MEMORANDUM

To: Development Review Board
From: Mary O'Neil, AICP, Senior Planner
Date: March 17, 2015
RE: ZP15-0810SP 10 University Place

Request: Sketch Plan Review for UVM undergraduate student housing on Central Campus.

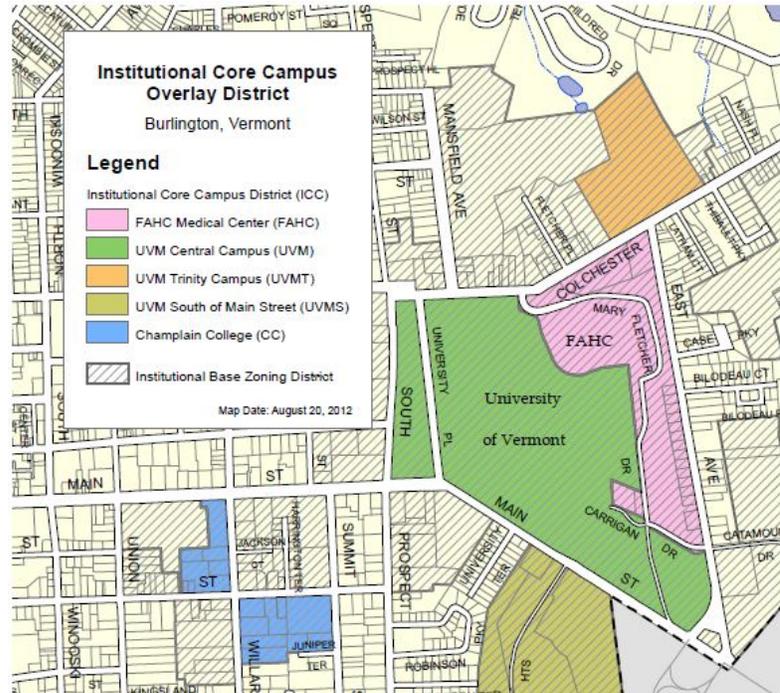
2. *UVM Central Campus (ICC-UVM).* The proposed development is within the core campus. See Map 4.5.2-1.

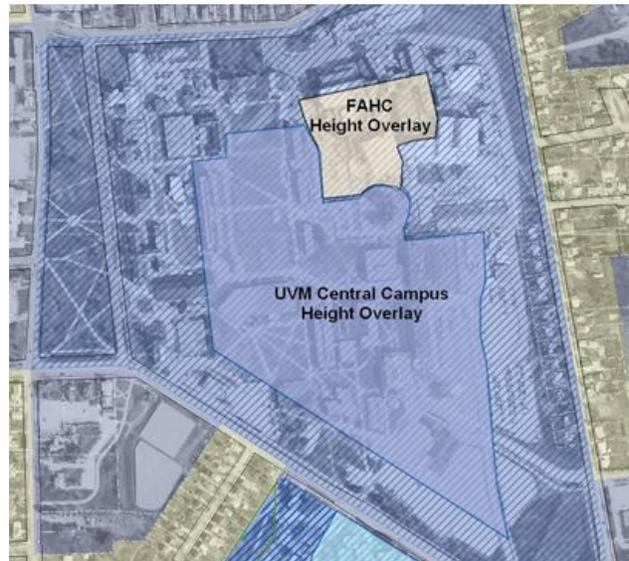
No surface parking spaces are illustrated on the provided site plan. The applicant will be required to confirm compliance with the Joint Institutional Parking Plan, UVM chapter, upon submission of formal application.

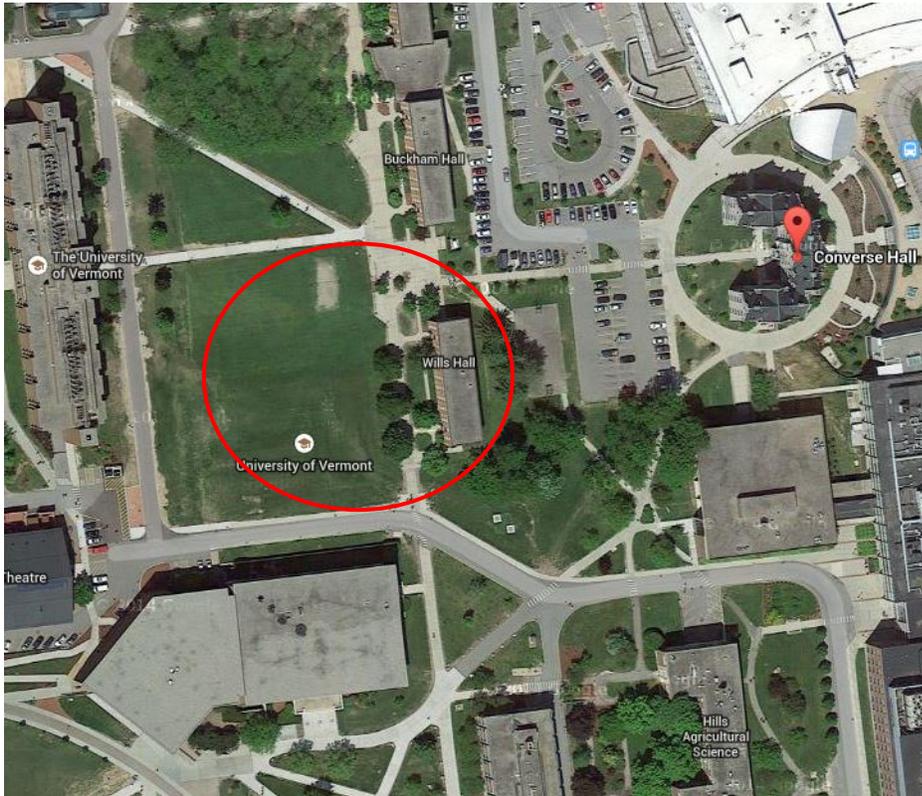
The arrangement of the buildings appears to maximize southerly exposure which will have a direct benefit for solar gain. A green roof is proposed on the westerly building which will have environmental and stormwater benefits, if installed.

More information will be required for the landscaping plan to determine potential benefit.
